# **NATIONAL BOARD SUBGROUP INSTALLATION**

## **MINUTES**

Meeting of July 13<sup>th</sup>, 2021  
Cincinnati, OH

| DWG / DIR No:<br>2000579238   | Ver:<br>01 |  |  | Sht: 1<br>Of: 3                   |

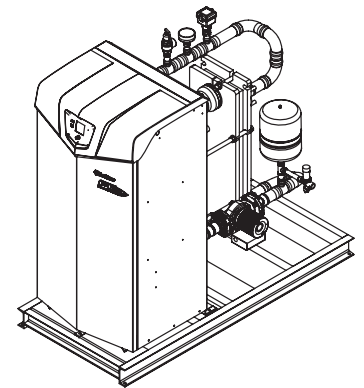
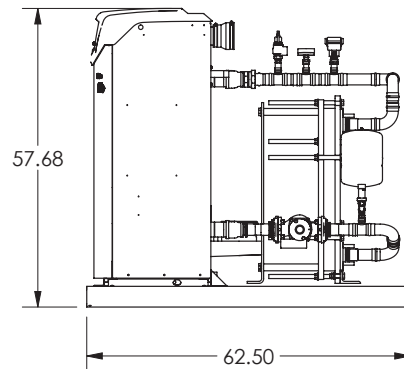
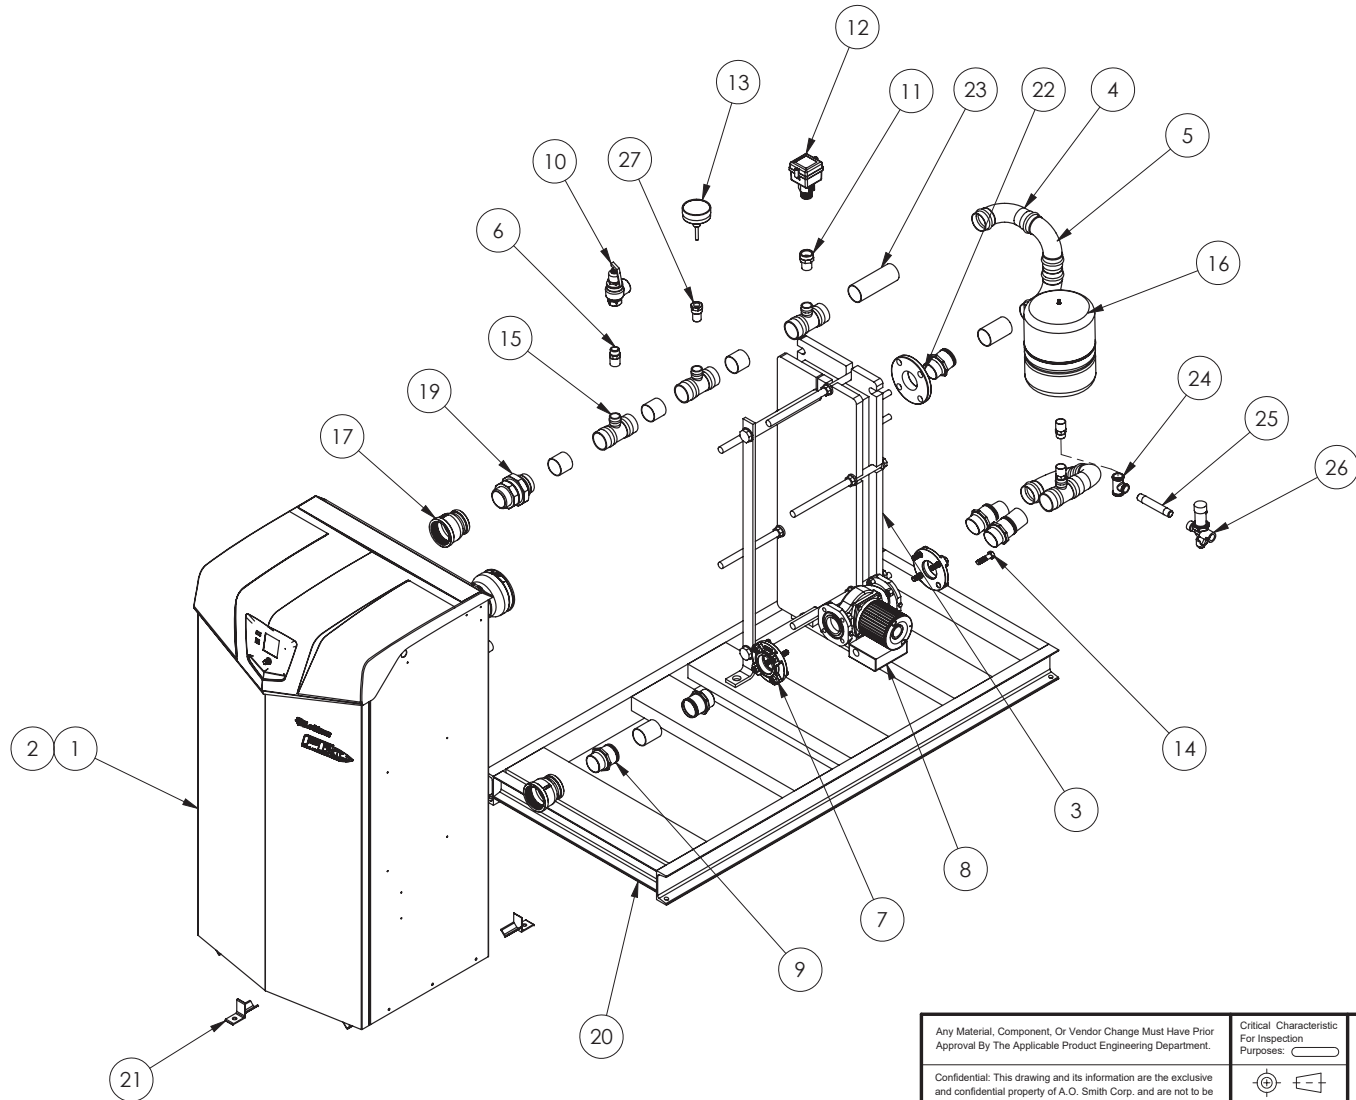
Yes, this is a package that we build. Attached is a drawing that may be a little more clear.

Now if the plate and frame heat exchanger were to be serviced, that would connect to the primary pool loop. We provide instructions to install stop valves between the plate and frame heat exchanger and the primary loop so the heat exchanger can be serviced without draining the system.

Jeff, if this is a package that Lochinvar builds is it possible to see the drawing in PDF of how it is piped? Also in reviewing the IOM, the instructions on servicing or draining the boiler/heater is not real clear.
